SANDSTONE PRECINCT

23-39 BRIDGE STREET
SYDNEY NSW, 2000

**PROPOSED PLANS - LANDS BUILDING -
LOWER GROUND, EDUCATION BUILDING -
BASEMENT 01**

FOR APPROVAL

Date Printed: 20/7/20

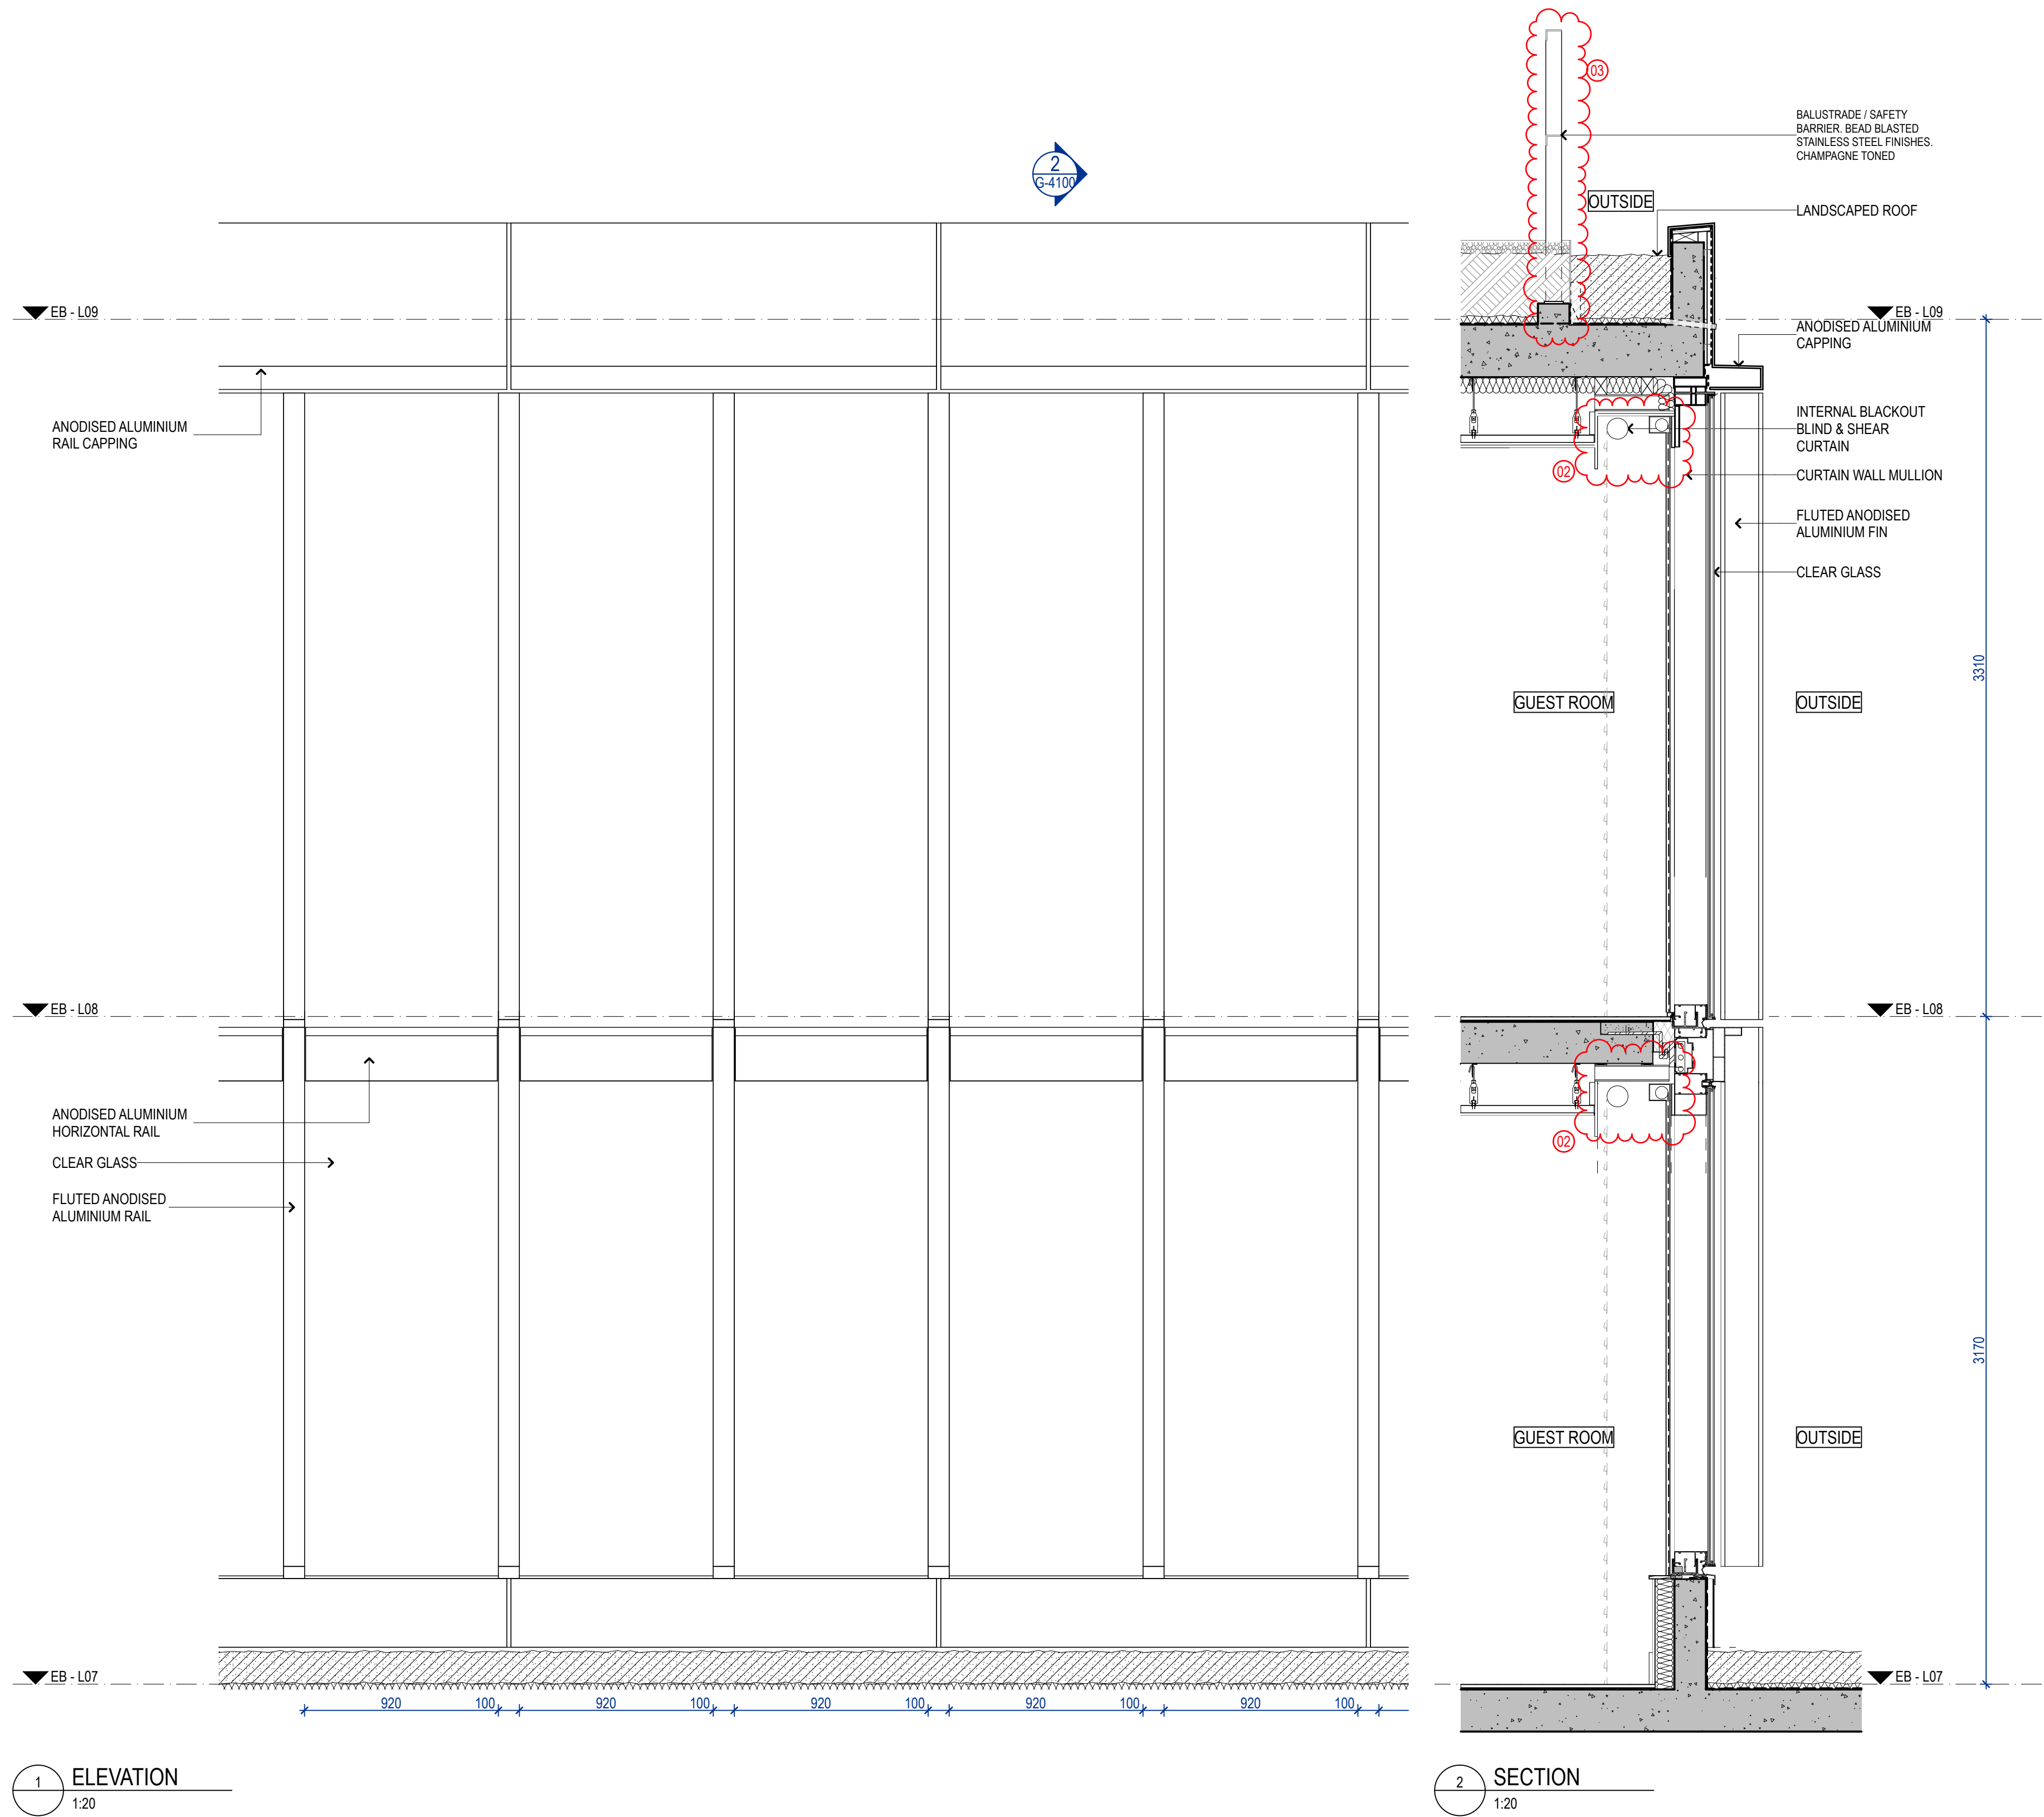
CHANGES LEGEND:
(01) CURVED GLASS CHANGED TO 1500MM RADIUS
(02) UPDATED INTERNAL BLACKOUT BLIND & SHEAR CURTAIN DETAIL
(03) ADDED BALUSTRADE
